NHSScotland Design Assessment Process

Project No/Name: LK06 - Monklands Re-fresh
Business Case Stage: IA
Assessment Type: Desktop
Assessment Date: February 2017 (update 23 Aug 2017)
Response Issued: 19 Sept 2017

Monklands Refurbisment/Replacement: Design Statement

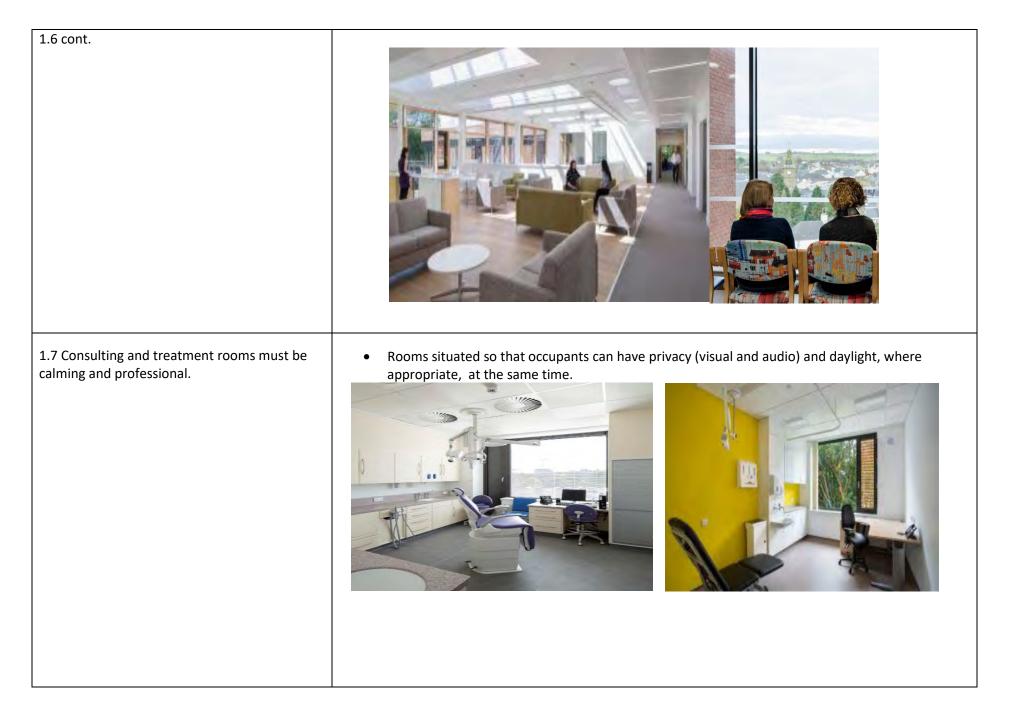
- Section 1.4 talks about an initial space with places to sit, get refreshments daylight and views, but is illustrated with spaces with no views, and little seating. (DISCHARGED)
